CITY OF ALBUQUERQUE

Re: Dorado Montano Townhouses
5915 Golden NW
Traffic Circulation Layout
Architect's Stamp 06-01-2020 (E10-D079)

TRAFFIC CIRCULATION LAYOUT APPROVED

TRAFFIC CIRCULATION PLAN

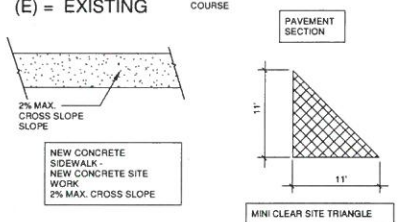
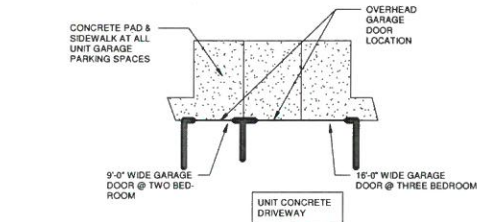
ALL WHEELCHAIR RAMPS LOCATED
WITHIN THE PUBLIC RIGHT OF WAY
MUST HAVE TRUNCATED DOMES.

CONDITION OF C.O. (FINAL) APPROVAL:
SIDEWALK EASEMENT FOR 24 FT. DRIVEPAD
AND FIRE HYDRANT (KEYED NOTES 3 & 7)
BE APPROVED, ACCEPTED AND IN PLACE (NSF)
